APPLICATION FOR THE DISCHARGE OF DETAILS FOR PLANNING CONDITIONS - CASE OFFICER REPORT

APPLICATION REFERENCE:	PL/2026/01447
APPLICATION TYPE:	DISCHARGE OF Details for CONDITIONS
SITE ADDRESS:	West Winterslow Workshops, Back Drove, off The Street, SP5 1RY
PROPOSAL:	Discharge of conditions 5 future maintenance of the structures & 6 pre-construction standard of planning application PL/2025/02053 <i>(Variation of conditions 2 (Plans list), 3 (Materials), 5 (Tree details), 8 (PD rights), and removal of Condition 15 for installation of a package treatment plant (alternative scheme for connection to mains drainage) for PL/2021/09194)</i>

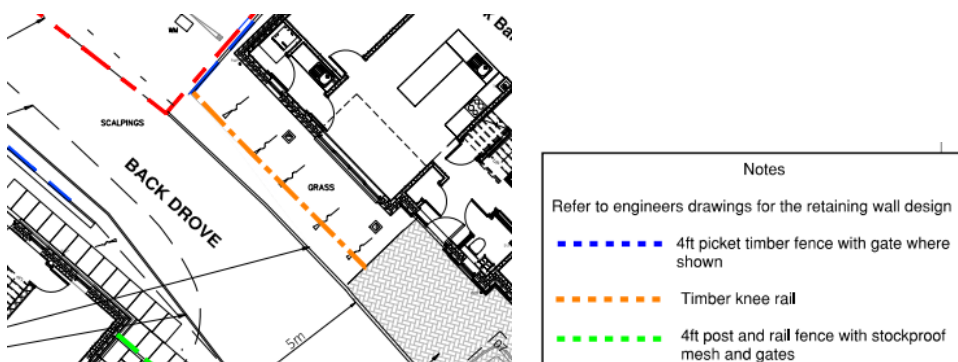
The highway along the entire length of the application site has been regraded and compacted with a type one MOT stone and agreed with rights of way. The width of the highway has now been demonstrated, and we confirm the 5m width can be witnessed and will remain a part of the byway 'BOAT'. All surfacing, drainage and boundary treatments are completed, adjacent to the BOAT. Images included below, more can be provided on request.

The rights of way team are content with the finished width of the byway and commented:

The attached is a photo of the byway from my last visit in February. This was the narrowest section but I was happy with the available width then. The surfaced area was probably wider than the original design and the grass verge was narrower on the left of that photo as a result,

but still provided a refuge should people need to avoid vehicles on that stretch. The builders were still on site then finishing some of the works.

The narrowest section looks to be just under 5 metres. The measurements are not precise so we have used 5 metres as a rough guide to the minimum width that should be available. However, if it is 10 to 20 cm less in the narrowest section I think this is acceptable.
